**Public Comments on the Proposed Revisions to Section 4.2  
Chapter 2 (SCR) of the  
Control Cost Manual**

## Chapter 2: Selective Catalytic Reduction (SCR)

**Figure 5-2. Catalyst Exchange Frequency: Eastern Bituminous Coal**

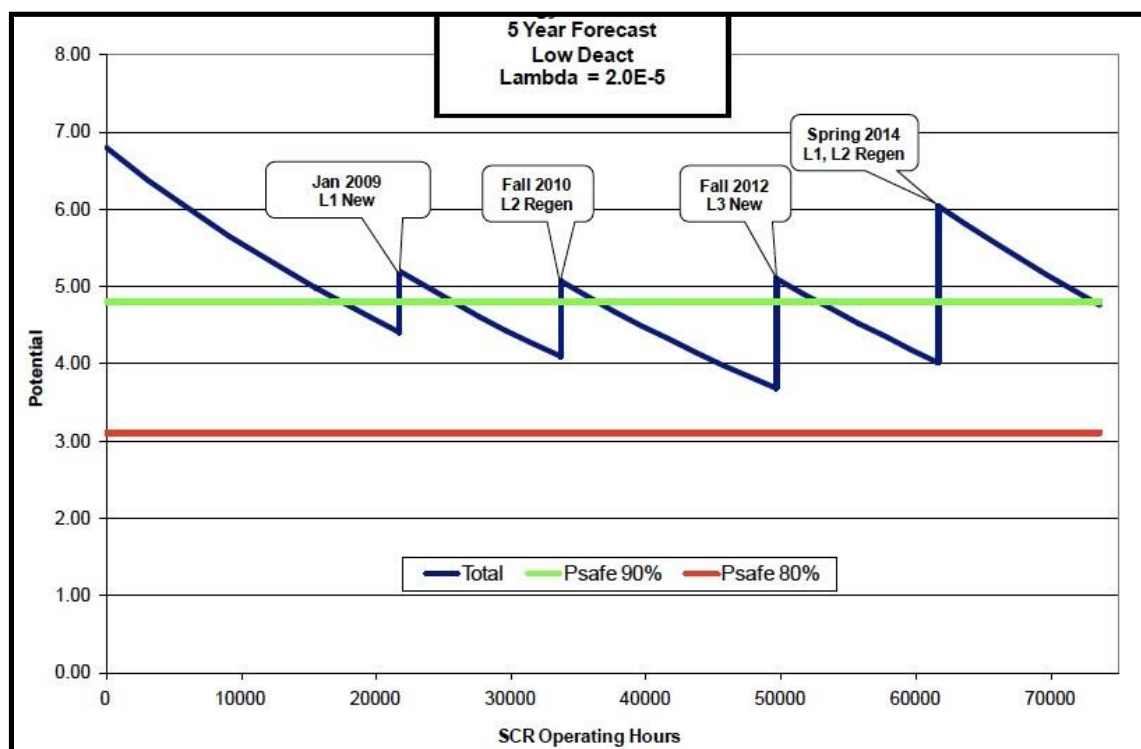
Figure 5-2 presents an example exchange rate based on one catalyst supplier's analysis for a unit firing eastern bituminous coal. The metric of Figure 5-2 is the total reactor potential as comprised of the reactor potential of 3 layers in the reactor. Figure 5-2 shows that four catalyst exchange “events” are planned, installing five new layers of catalysts, over about 80,000 operating hours. One catalyst supplier reported that depending on wall thickness a total of 12

catalyst layers would be required in 20 years.<sup>61</sup> Less frequent catalyst replacement schedules can be found but the experience reflected in Figure 5-2 is common.

**Figure 5-3. Authentic Reactor Potential Decay: PRB Coal with Ash Blockage**

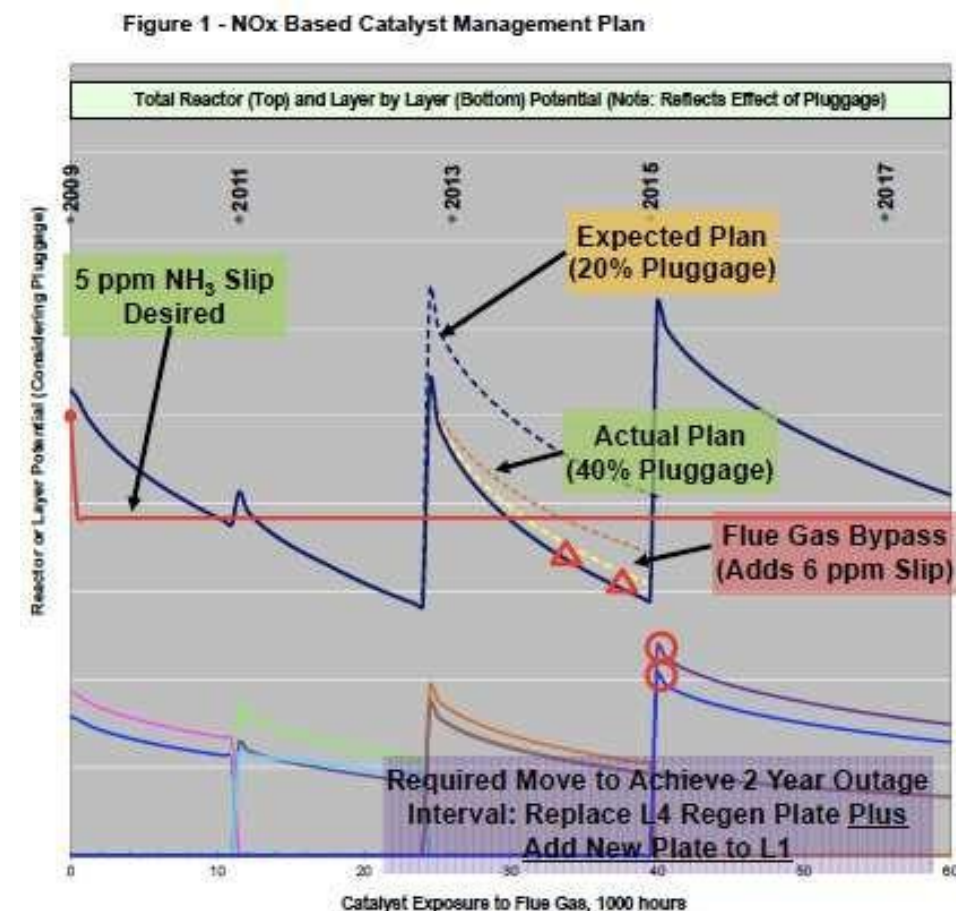
Figure 5-3 presents a more authentic catalyst management plan – showing the relative change in reactor potential for a large PRB-fired unit that incurred ash plugging.<sup>63</sup> Figure 5-3 shows the erratic rate of decay of reactor potential (on a relative basis) and how catalyst pluggage from ash affects the actual reactor potential realized. Figure 5-3 does show the owner abided by the original plan of a 24,000 operating hour changeout – but after about 12,000 operating hours the reactor potential was less than the minimum required for 5 ppm residual  $\text{NH}_3$  – meaning residual  $\text{NH}_3$  emissions were higher than planned. Figure 5-3 also shows how the role of catalyst pluggage can compromise reactor potential, and how in this case adding two layers of catalyst

(changing one and adding a second to the empty spare cavity) is necessary to achieve 2 operating years between outages.
